EQUIPMENT UPDATE

Log Number: EU-07-386

Part Description: COMPRESSION FITTING
Models Affected: CMA-44, CMA-66, CMA-180, CMA-180T

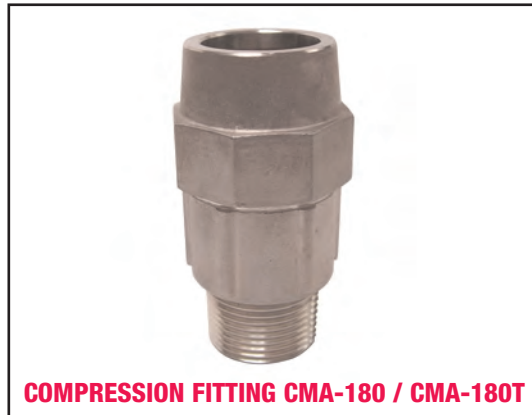
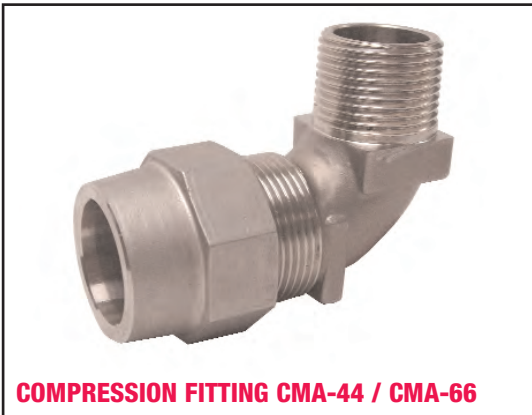
The parts shown in the images have been known to deteriorate over time when manufactured from brass. CMA has committed to a tooling process and both parts are now made of stainless steel casting. This improvement in material will add many years of service free reliability to these components.

New Part Number: 213.20 - CMA-44, CMA-66
221.20 - CMA-180, CMA-180T
